**PLANNING COMMISSION  
STAFF REPORT**

October 6, 2022

AGENDA ITEM: MAJ-22-0001: A final review of the Major Site Plan Application for a proposed 30-unit multi-family residential development to be in addition to the existing Alpine Inn on site.

CU-22-0001: A conditional use request to allow multi-family residential units in the Gateway District.

**Current Major Site Plan submittal (North Building):**

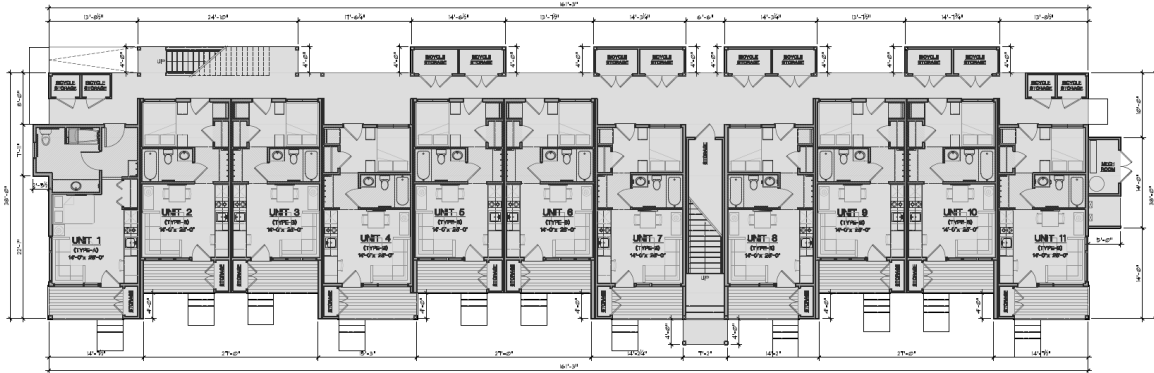
As oriented on the site plan, the north and south façades of the 22-unit building each are over 75-feet in length and are visible from public streets. As shown on the submitted elevations, the proposed structure is utilizing a minimum of four of the building elements as stated above on each of these façades. Building elements utilized include balconies on the first and second levels; building elements that provide shelter from natural elements including covered decks; offsets, insets and architectural features to add variety of depths to the wall plane; change in texture and material; variation in roof planes and forms including gables; and variation in window sizes and shapes. The application meets this standard.
